Docket No. 50-333

The amendment changes the Technical Specifications to permit fuel reloading and Cycle 8 operation. Included in the Cycle 8 core will be four Westinghouse QUAD+ demonstration fuel assemblies.

JAMES A. FITZPATRICK NUCLEAR POWER PLANT

Amendment No. 109
License No. DPR-59

Figure 3.1-2

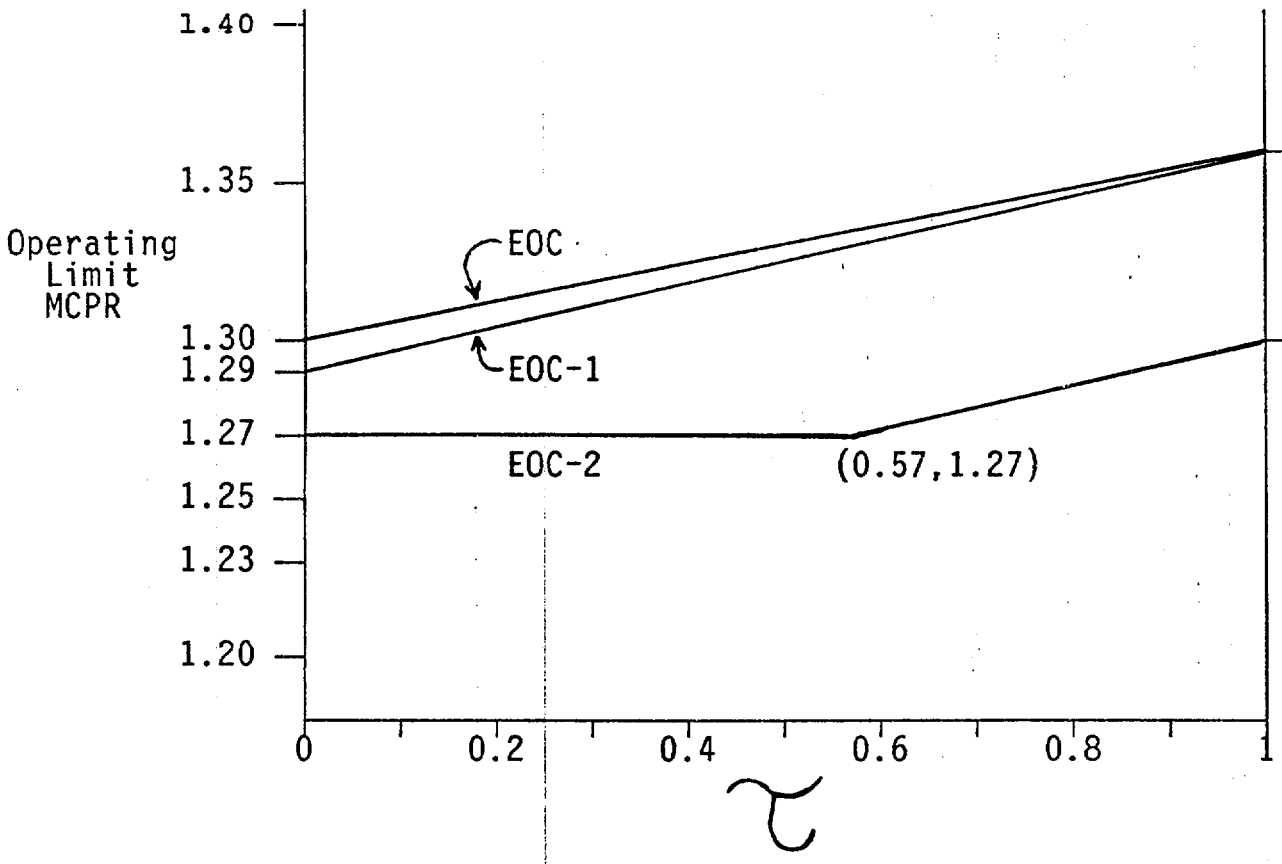
2. If requirement 4.1.E.1 is not met (i.e. $\tau_B < \tau_{AVE}$) then the Operating Limit MCPR values (as a function of τ) is as given in Figure 3.1-2.

*Note: Should the operating limit MCPR obtained from this figure be less than the operating limit MCPR found in Specification 3.1.B.1 for the applicable RBM trip level setting then Specification 3.1.B.1 shall apply.

Figure 3.5-11

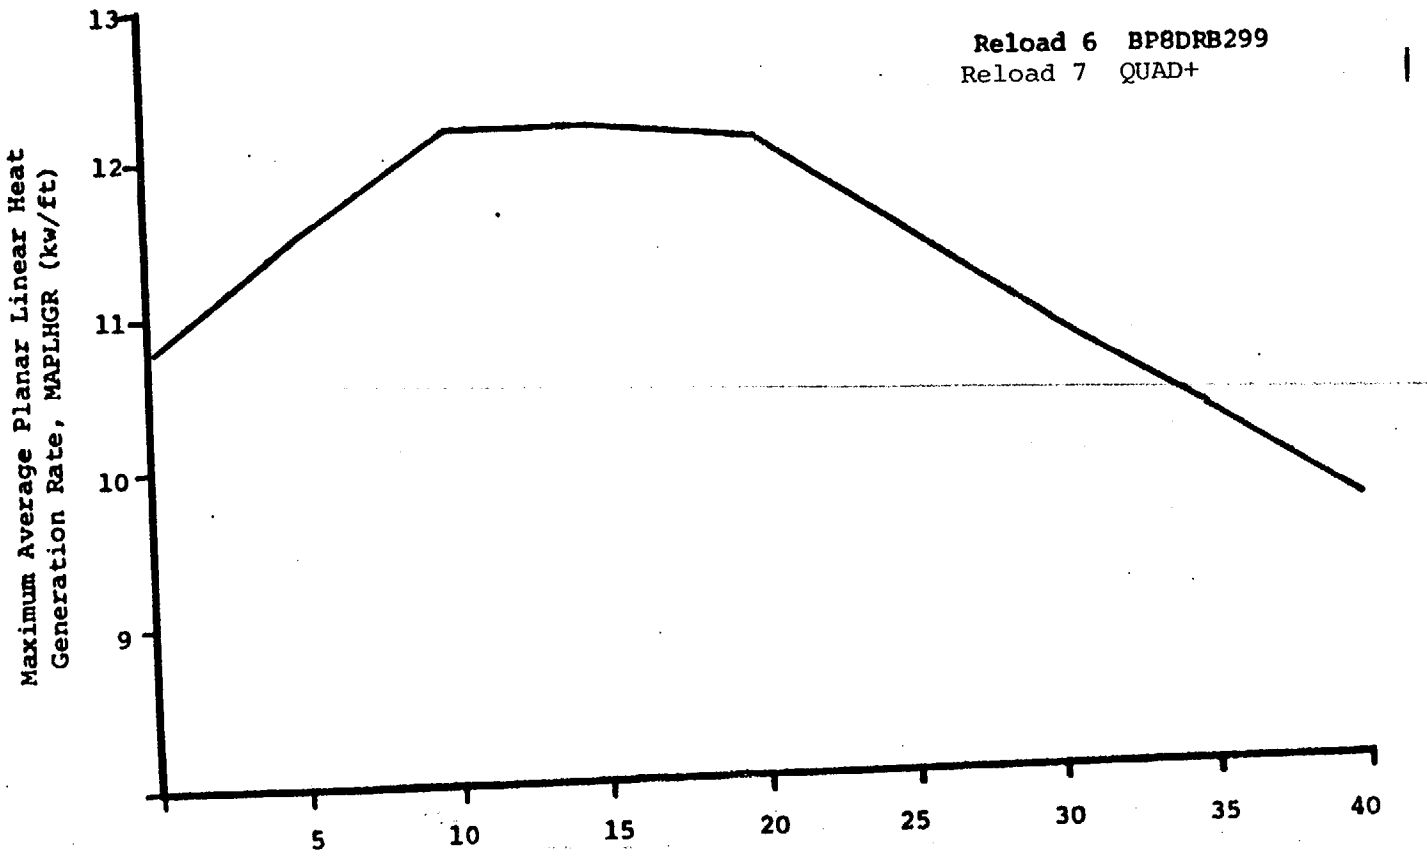
For single-loop operation, these MAPLHGR values are multiplied by 0.84.

Figure 3.5-12

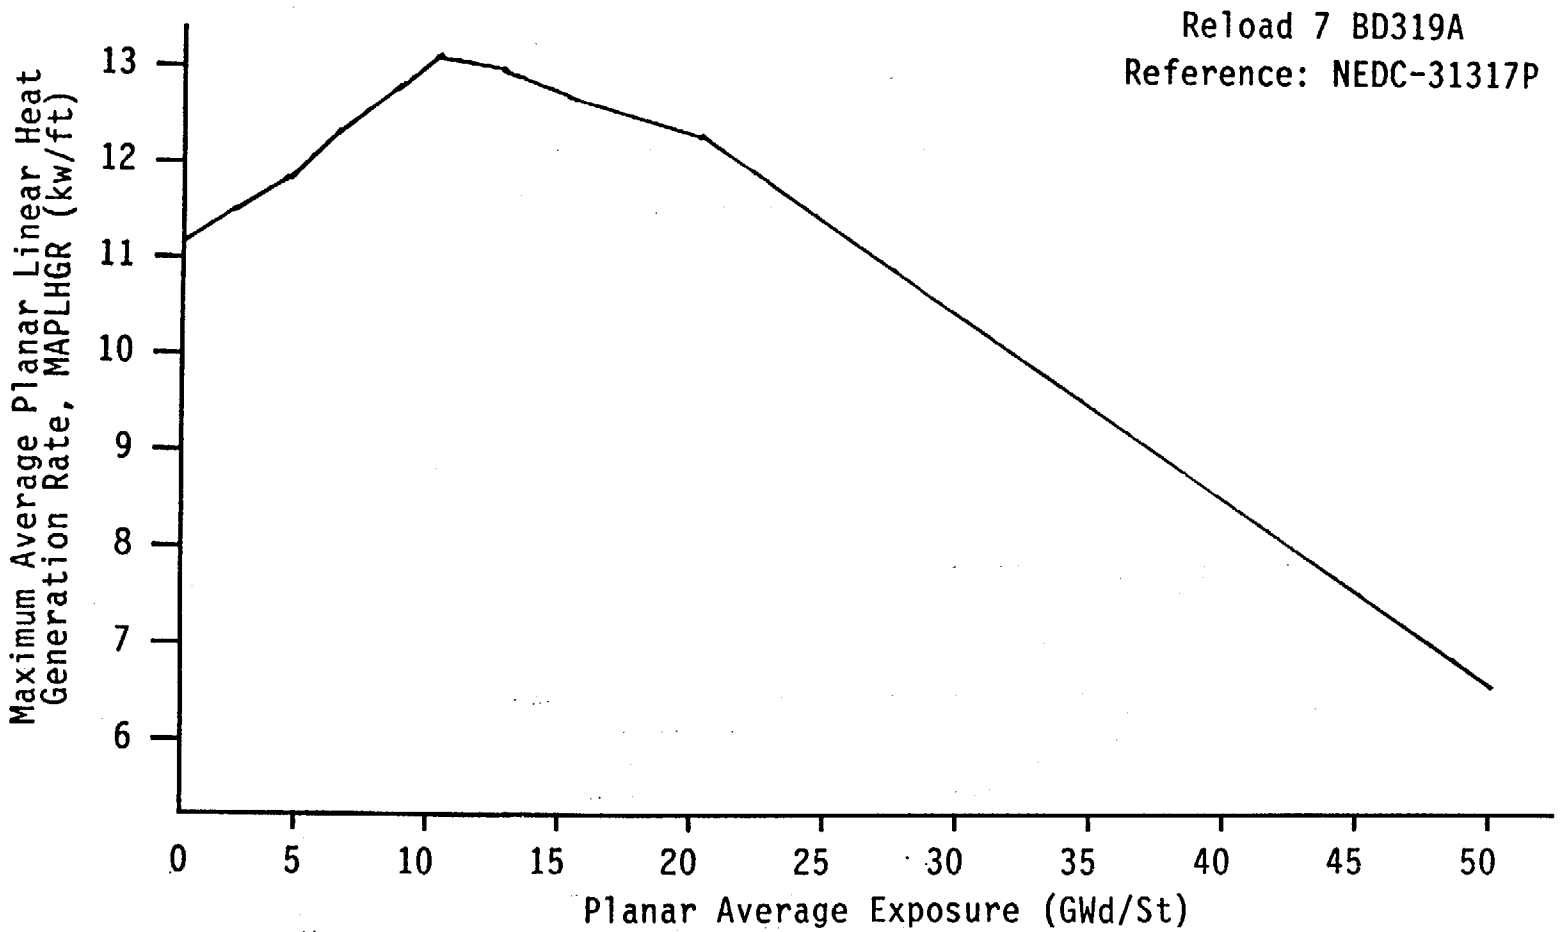
For single-loop operation, these MAPLHGR values are multiplied by 0.84.

This curve represents the limiting exposure dependent MAPLHGR values.
